SECTION 905 -- PROPOSAL (CONTINUED)

PROJECT: NHPP-0020-01(263)/108848301 - Rankin

SECTION 904 - NOTICE TO BIDDERS NO. 4496

Bridge Preservation on I-20 over US 80 (Bridge Nos. 60.1A & 60.1B), known as Federal Aid Project No. NHPP-0020-01(263) / 108848301 in Rankin County.

WK. NO.
REV-1

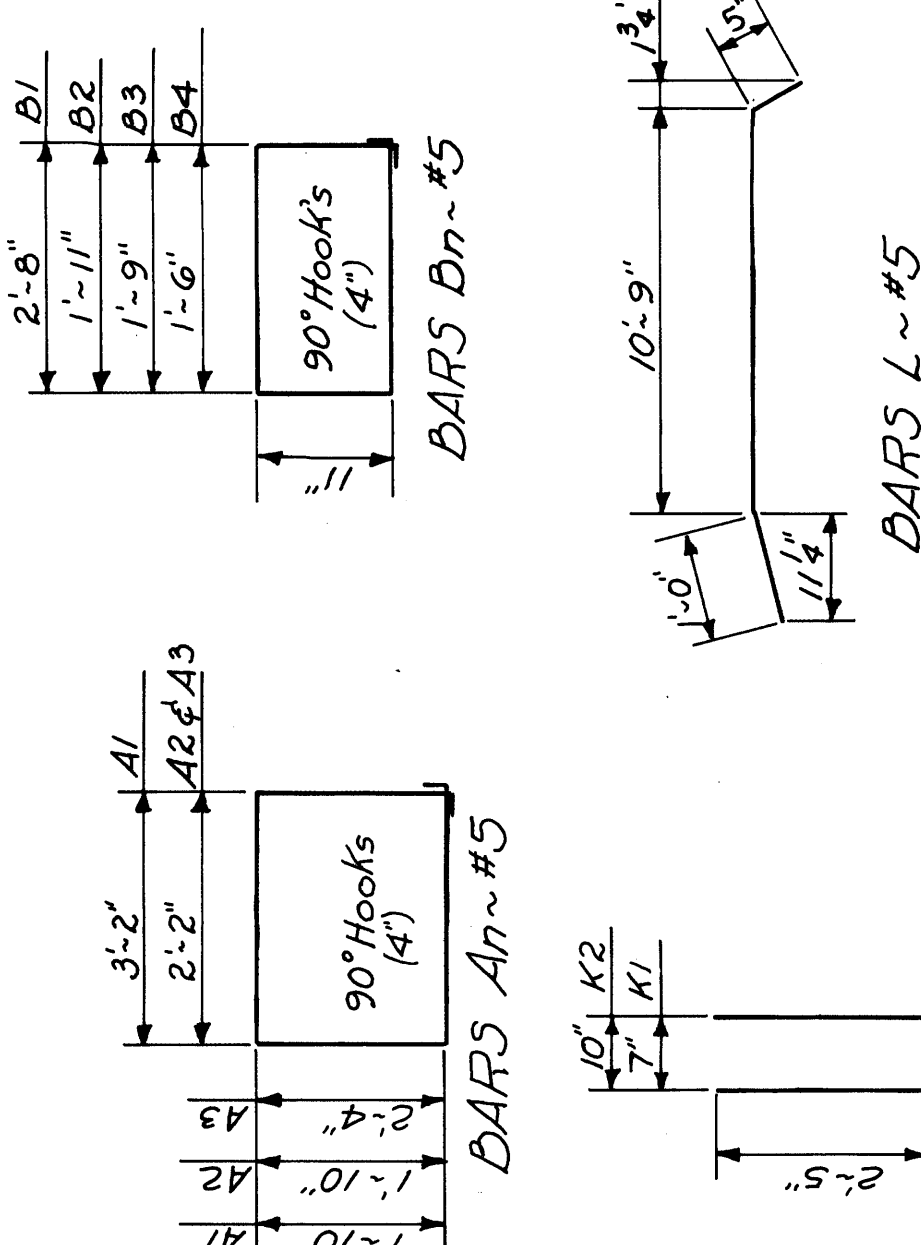
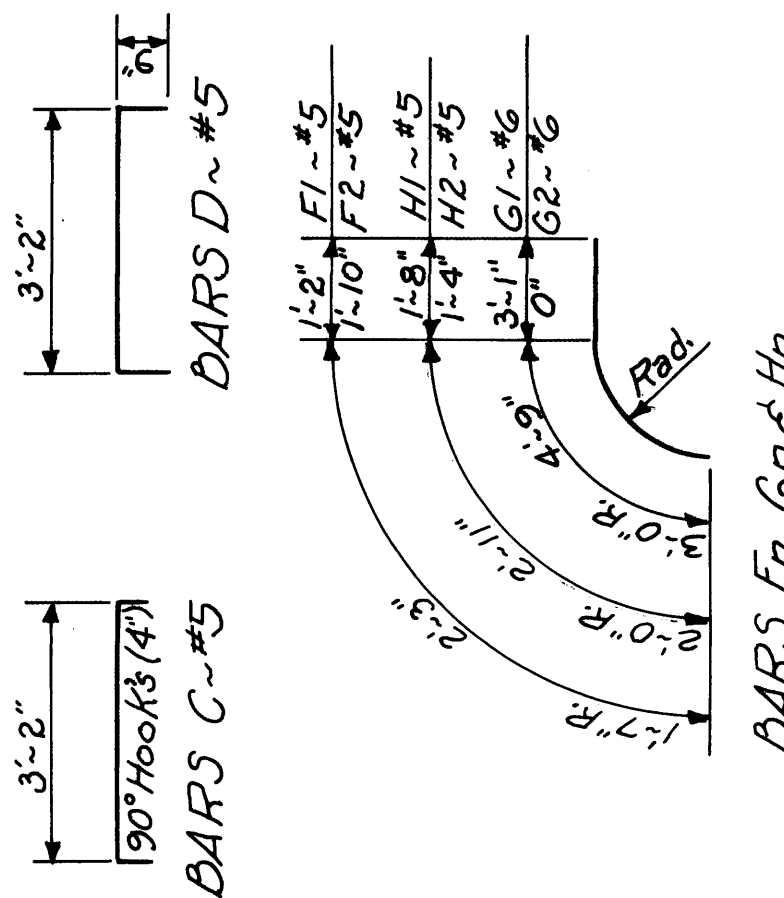
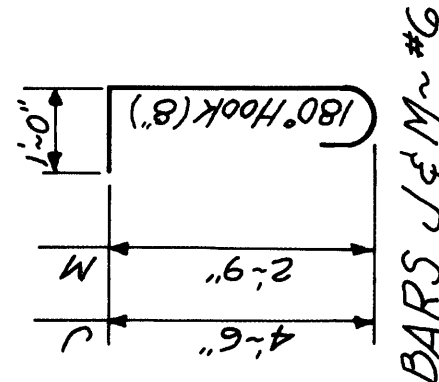
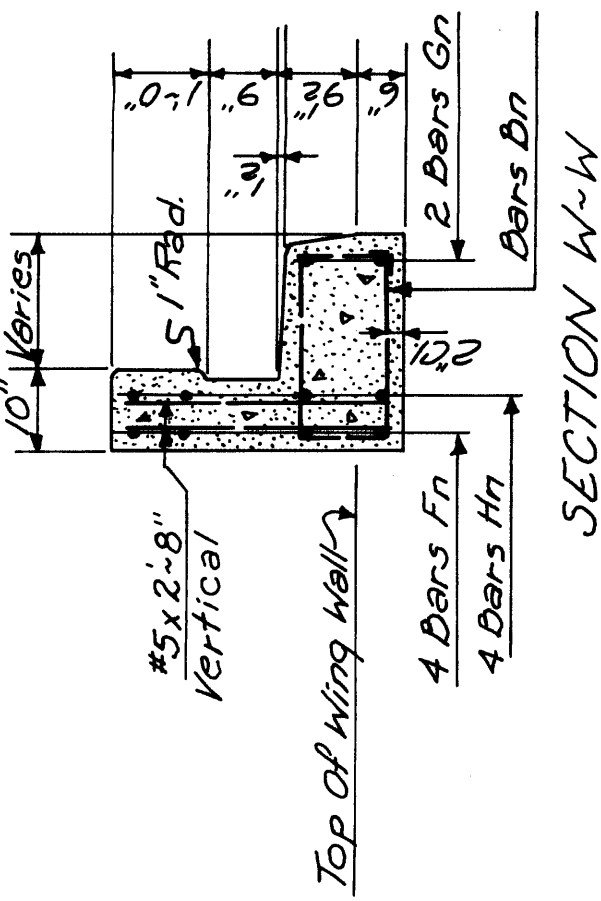
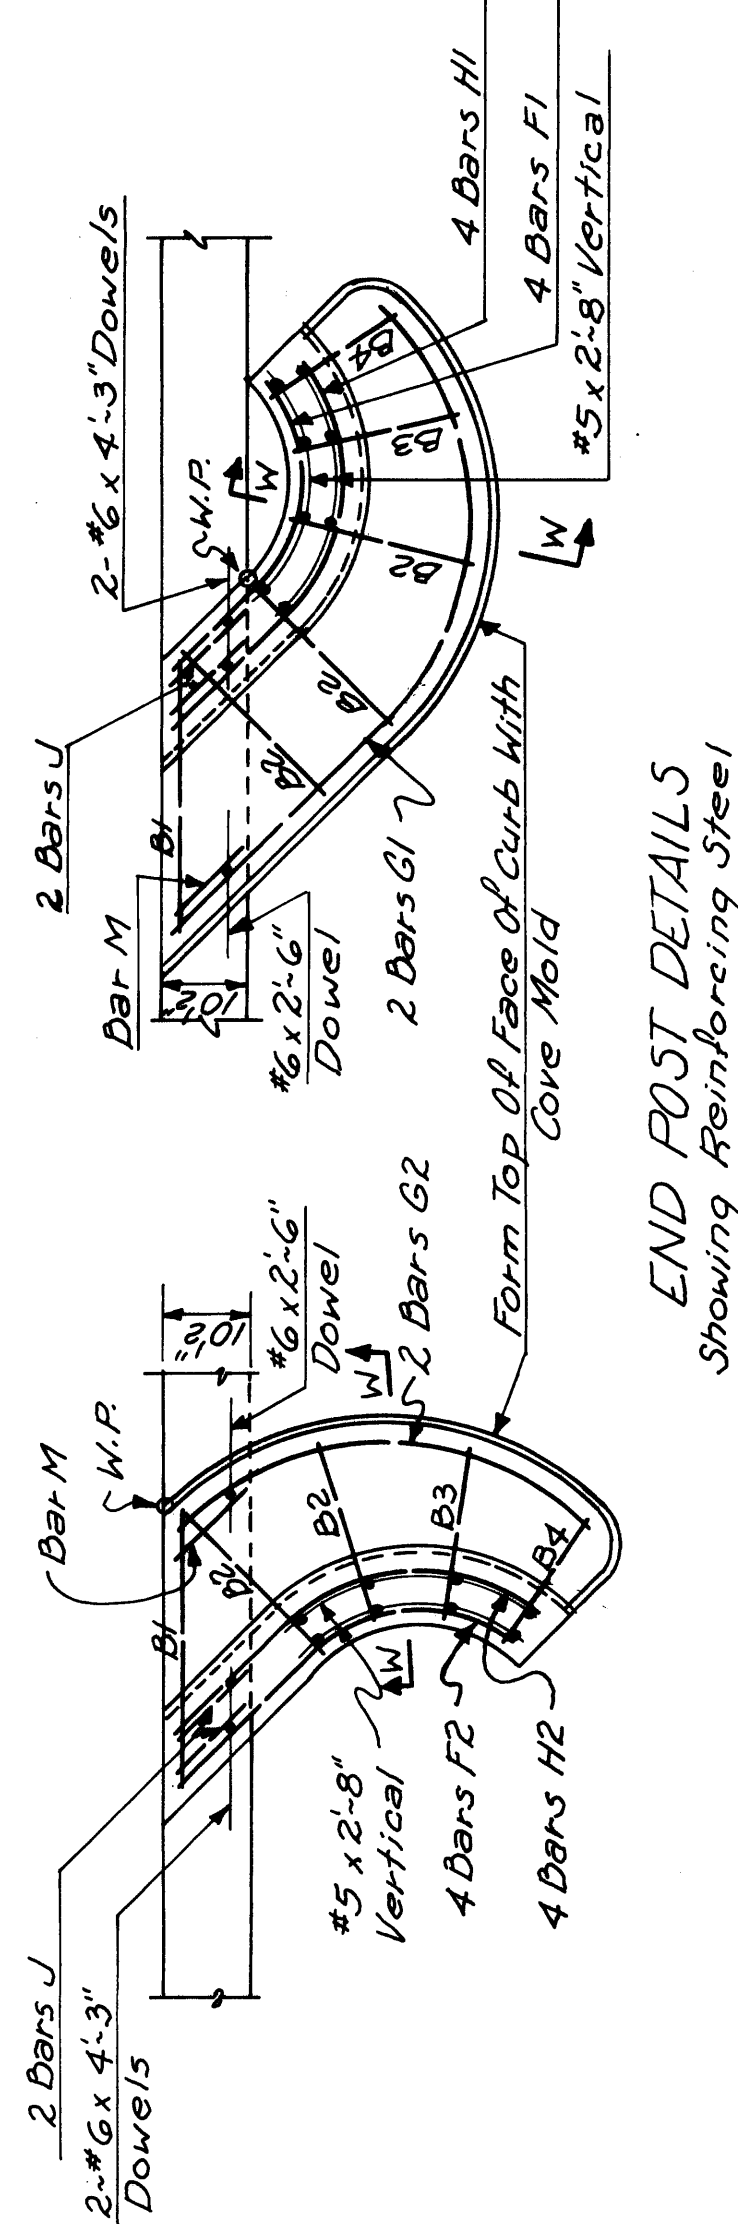
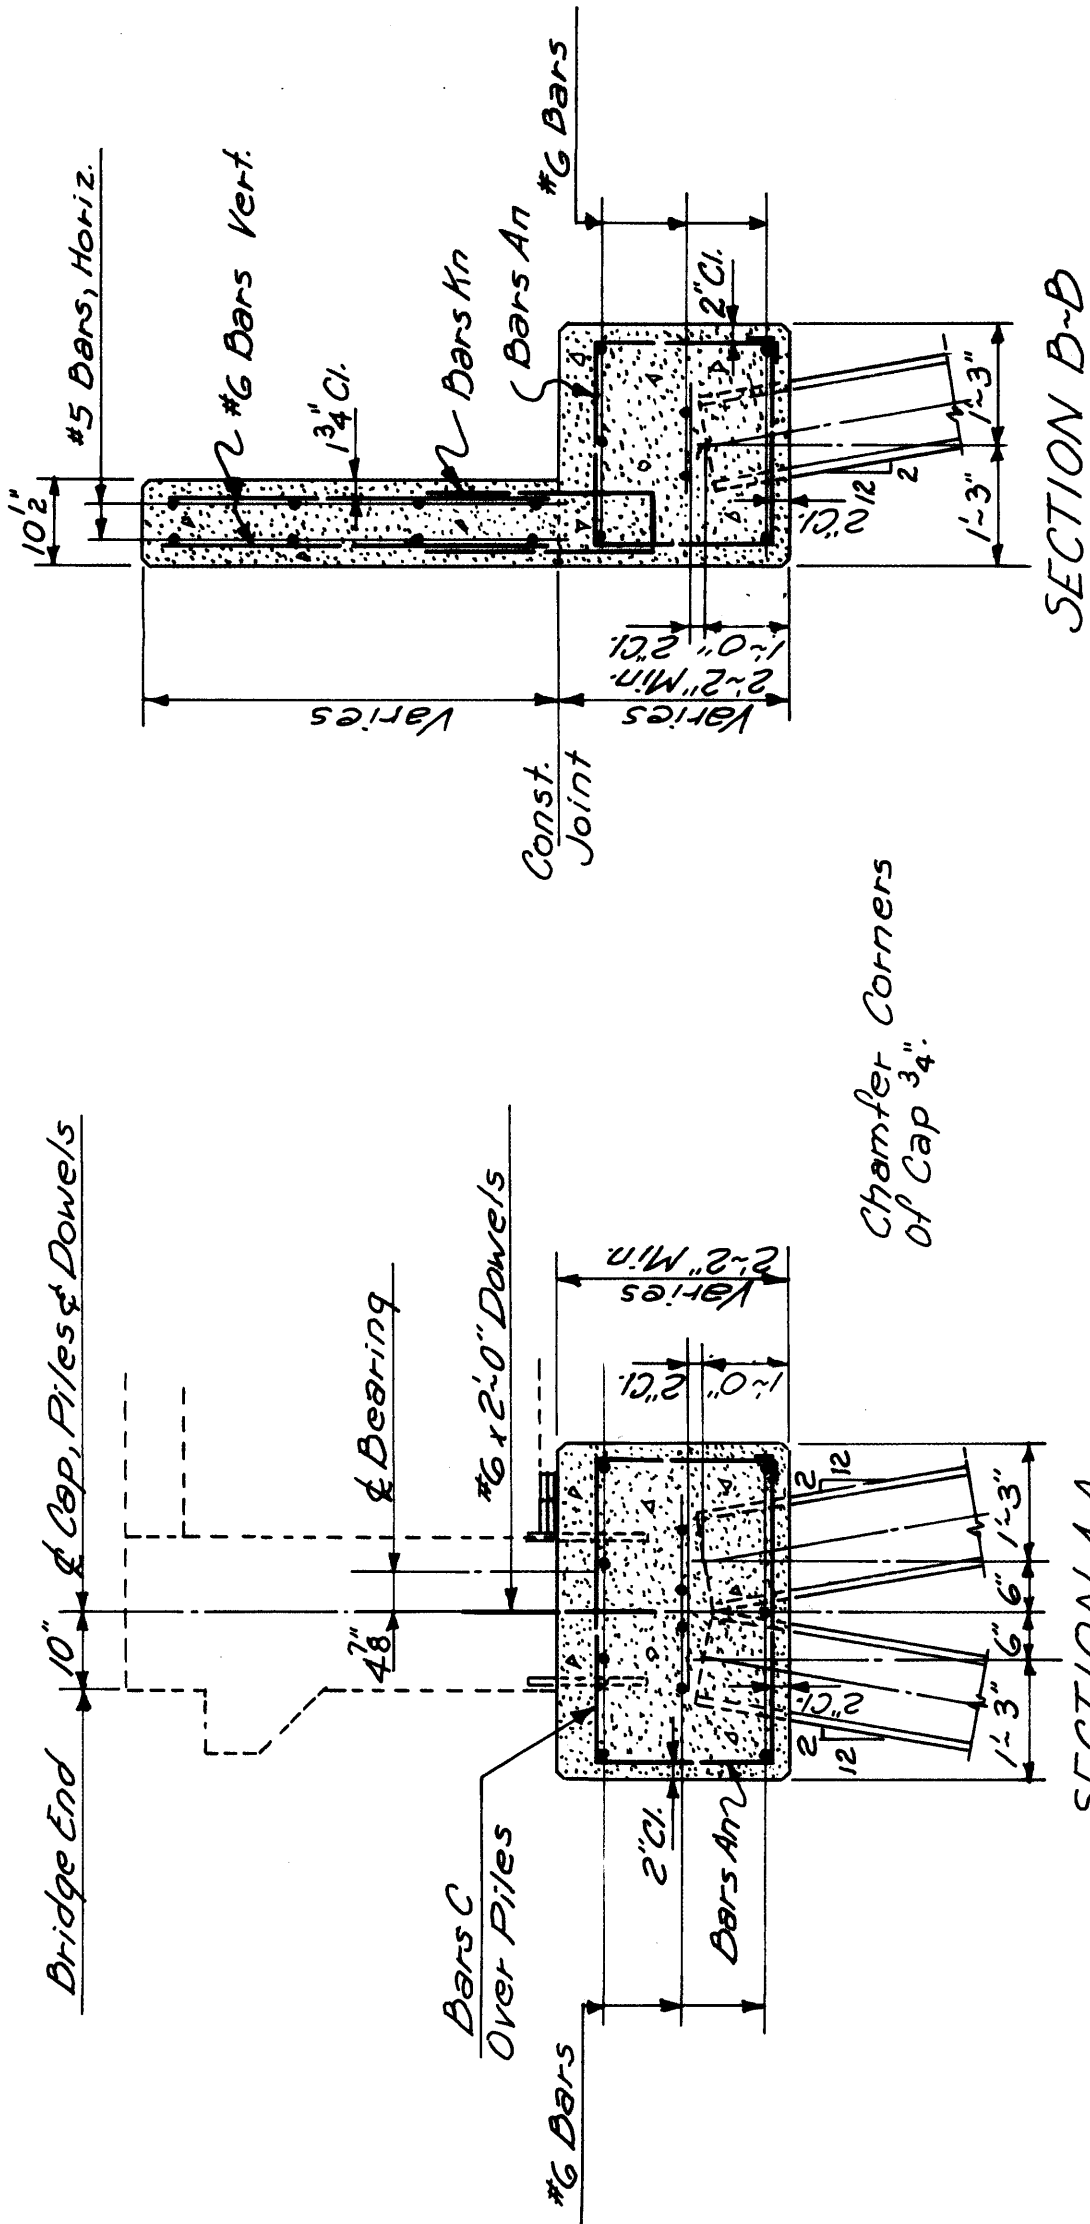
DATE	1st ORDER	ADDENDUM	2nd ORDER	BY	WK. NO.	DESCRIPTION
8-8-2022	6" CHANGED TO 8"			HLW	JRCP-1
